# CITY PLAN COMMISSION STAFF REPORT

**Fashionbilt**

CD-CPC-2021-00174

UR Rezoning + Development Plan

1 LANDSCAPE & STREET TREE PLAN  
1" = 20'

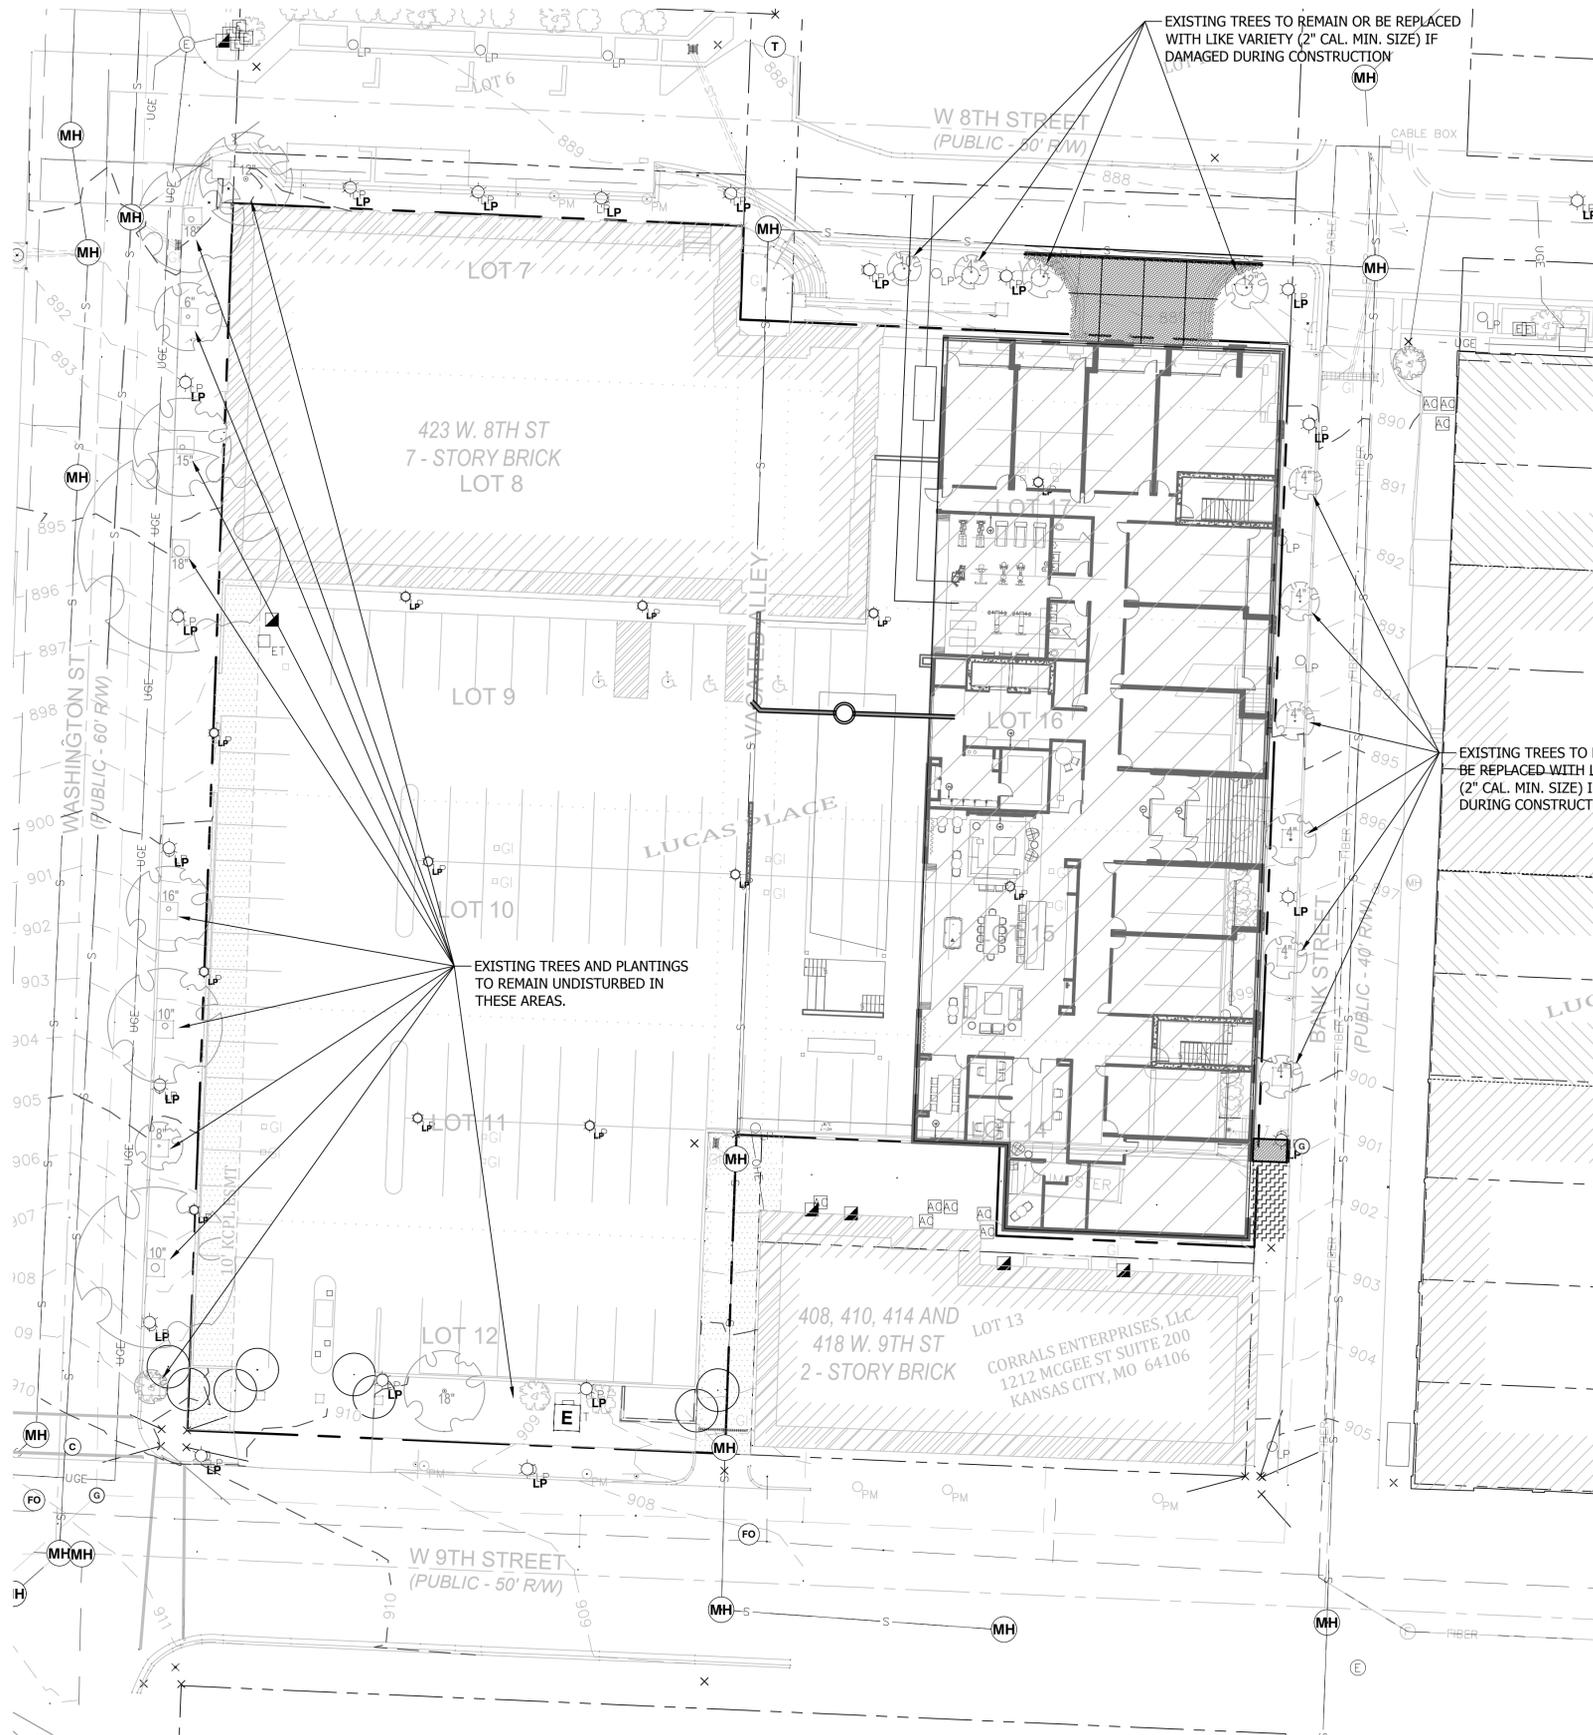
3. The south façade of the parking garage should be "activated" more. Review the Kansas City Downtown Streetscape Master Plan. Staff suggestions include, incorporating more landscaping into the buffer between sidewalk and garage

12/21/2021. Comment not resolved. (12/14/2021)

7. Revise plans to show streetscape improvements on 8th Street that are consistent with the Kansas City Downtown Streetscape Master Plan. (12/14/2021)
